APPLICATION NO.	FILING DATE	FIRST NAMED INVENTOR	ATTORNEY DOCKET NO.	CONFIRMATION NO.
10/688,261	10/17/2003	Norbert Hahn	P-US-PR-1088	4594

Office Action Summary	Application No. 10/688,261	Applicant(s) HAHN, NORBERT	
	Examiner GLORIA R. WEEKS	Art Unit 3721

DETAILED ACTION

**FIG. 3**

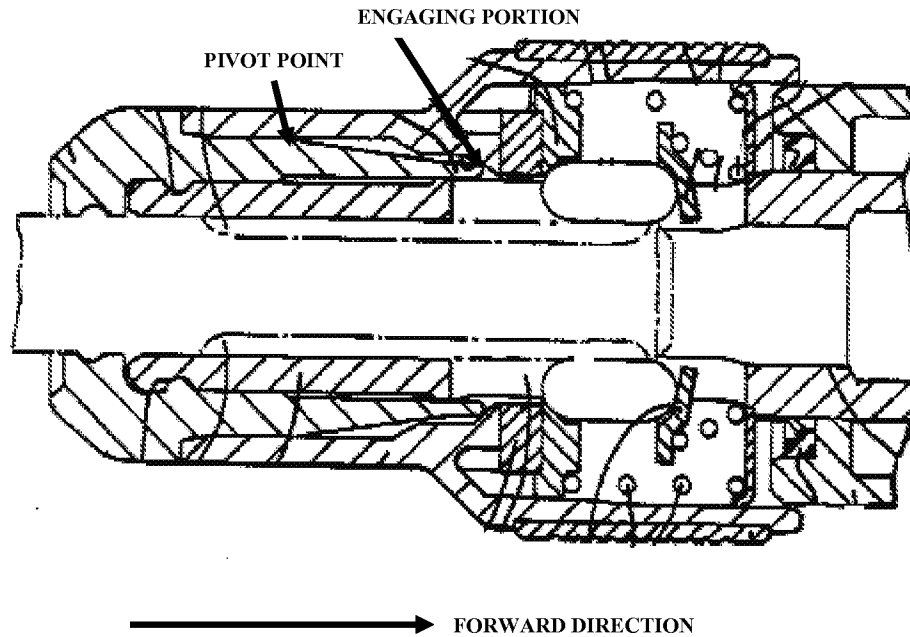
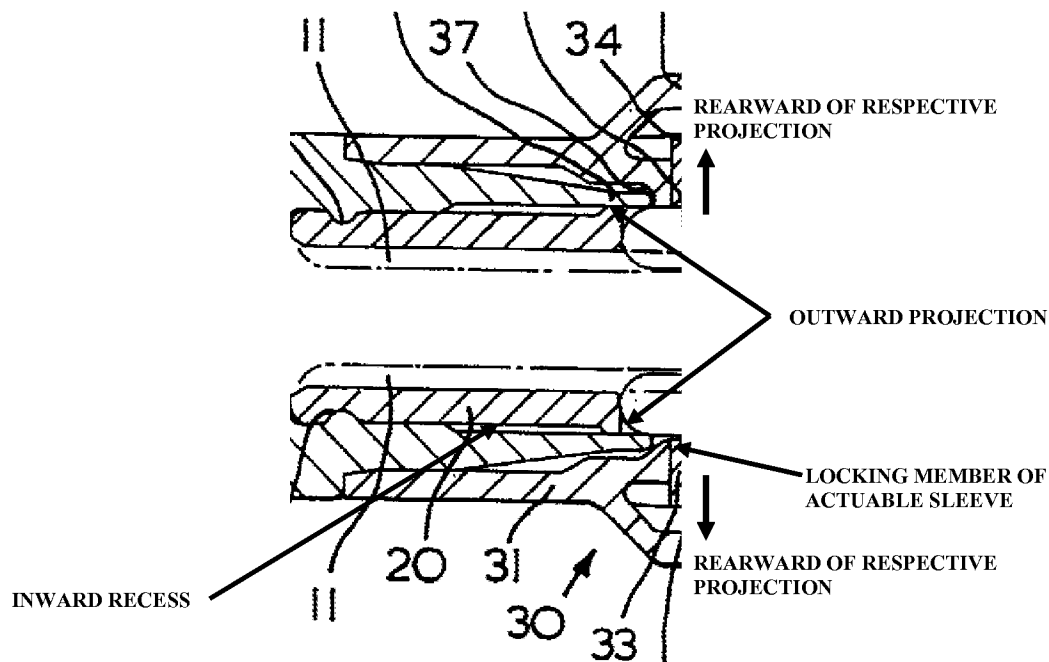
Regarding claims 1-4, 6, 7 and 33, Lauterwald discloses a tool holder that receives as tool 10, the tool holder comprising: a tubular main body 20; an elongated locking element 50, 60 mounted on the main body 20, the locking element 50, 60 having an engaging portion 62 forward of a pivot point that permits pivoting of the engaging portion 62 into engagement with a retaining collar¹ 41 to define a locked position (figure 2), and an unlocked position (figure 3) permitting a tool 10 to be inserted or removed from the main body 20; a manually actuatable sleeve 30 mounted around the main body 20 so as to be axially movable between a first position in which the engaging portions 50 of the locking element 50, 60 are held in the locked position, and a second position in which the engaging portions 50 of the locking element 50, 60 are movable to an unlocked position; a retaining ring 41 axially slidable with respect to the main body 20 independent of movement of the actuatable sleeve 30, and the retaining ring 41 is positioned rearward of the locking element 50, 60; and a spring member 49 that axially biases the retaining ring 41 forward into engagement with the locking element 50, 60 and a spring member 39 that biases the actuatable sleeve 30 into the locked position.

With respect to claims 9, 10, 14, 15, 17 and 20-25, Lauterwald discloses the locking element 50, 60 as an axially elongated feature that extends forward of a forward end of the main body 20, the locking element 50, 60 having first end including an elastic portion 62 that is pivotally mounted on the main body 20, such that pivotal movement of the elastic portion 62 of the locking element 50, 60 is facilitated by engagement of the engaging portions 50 within a recess/hole 22 formed in the outer surface of the main body 20. Lauterwald further discloses a subassembly including an actuator body 34; an axially slidable retaining ring 41 rearward of the locking element 50, 60; a spring member 49 biasing the retaining ring 41; and an axially slidable actuator ring 33, wherein the locking element 50 is movably positioned between the actuator ring 33 and the retaining ring 41 (figures 2-4).

The locking element 50, 60 includes an elastic portion 62 positioned radially outward from the main body; the actuable sleeve 30 having a locking member 38 that engages the elastic portion 62 of the locking element 50, 60 to hold the engaging portion 50 in the locked position (figure 2), and in a rearward position (figure 3) the locking element 50 is movable to an unlocked position. The main body 20 includes a reduced internal diameter portion engaged with and radially outward of the locking element in the locked position, and an increased internal diameter portion. Lauterwald further discloses the locking element 50, 60 positioned such that the pivotable elastic portion 62 is rearward of the outward projection portion, and the engaging portion 50 is located forward to the retaining ring 42.

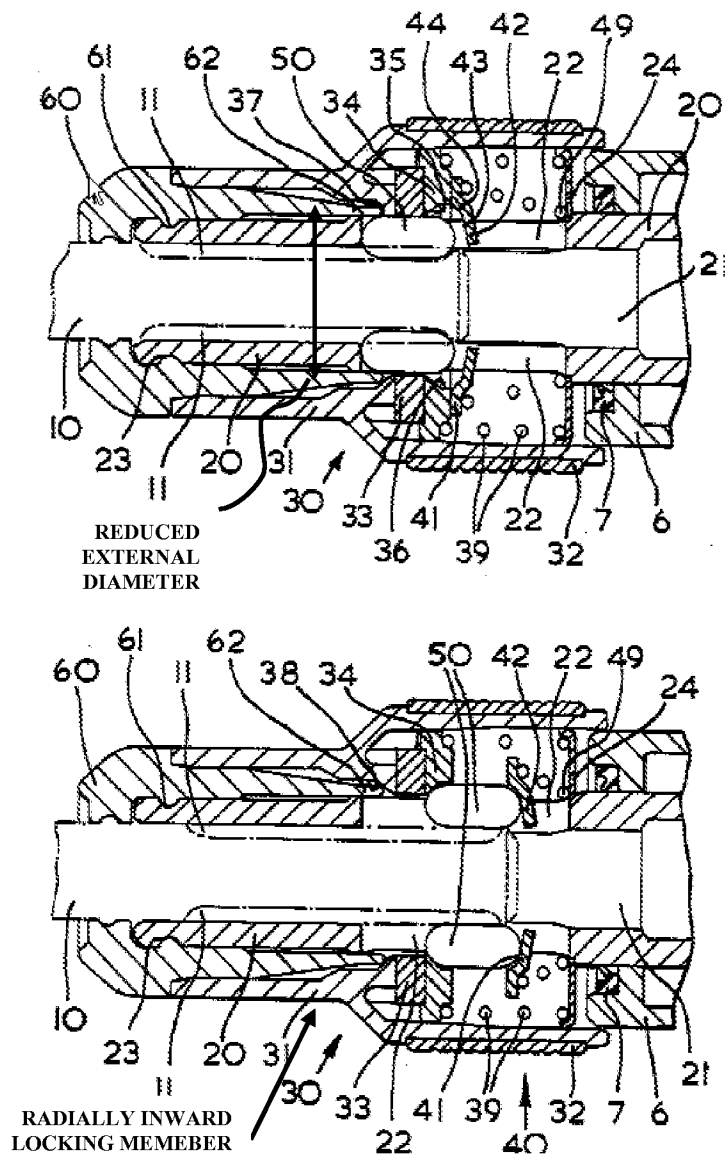
Regarding claims 12 and 13, the locking element 50, 60 of Lauterwald includes a portion positioned radially outward of the main body 20, and the actuable sleeve 30 includes a locking member radially inward of rear portion of the actuable sleeve 30, such that the locking member

engages the radially outward portion of the locking element when the sleeve is in the locked position, and the locking member is radially outward of reduced external diameter portion of the locking element when the sleeve is in the unlocked position (see illustration below).

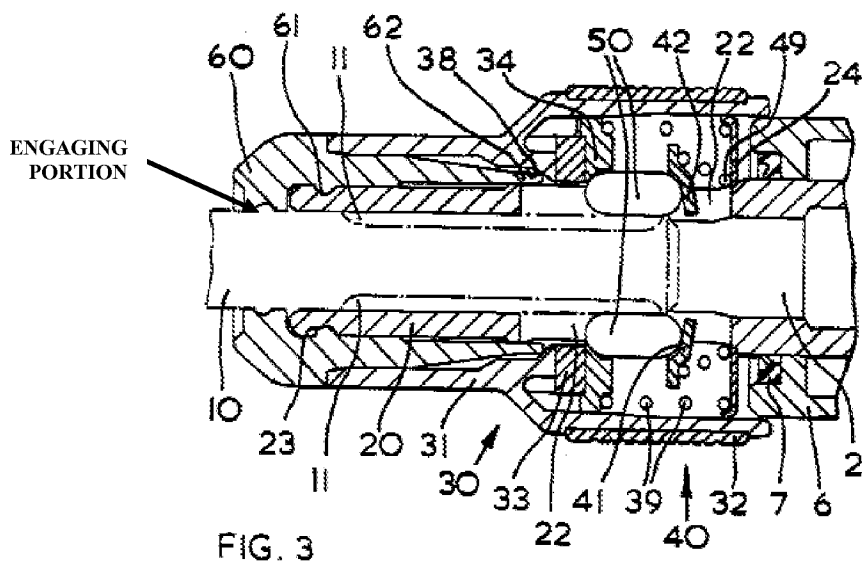
With respect to claims 1, 2, 17 and 18, Examiner is hereby providing an alternative interpretation of the tool holder disclosed by Lauterwald. Lauterwald is deemed to disclose a tool holder comprising: a tubular main body 20; an axially elongated locking element 50 movably mounted with respect to the main body 20, the element 50 having an engaging portion (see illustration below) movable between a radially outer unlocked position (figure 4) and an inner locked position (figure 2), in which the engaging portion is engaged with a retaining collar² of the tool 10; a manually actuable sleeve 30 mounted around the main body 20 so as to be axially movable between a first position in which the engaging portions 50 of the locking element 50, 60 are held in the locked position, and a second position in which the engaging portions 50 of the locking element 50, 60 are movable to an unlocked position; wherein a forward end of the locking element extends forwardly of a forward end of the main body 20 such that the a rearward 62 portion of the locking element is elastically pivotable and the engaging portion is positioned at a forward end of the locking element.

Applicant has argued that Lauterwald fails to disclose a pivotable engaging portion located forward of a pivot point. Examiner has illustrated above how the engaging portion is interpreted to be forward of the pivot point. Since Applicant has not articulated the forward direction relative to other elements of the apparatus that would distinguish the direction in a manner other than that interpreted above, Examiner maintains the rejection of Applicant's invention in view of Lauterwald.
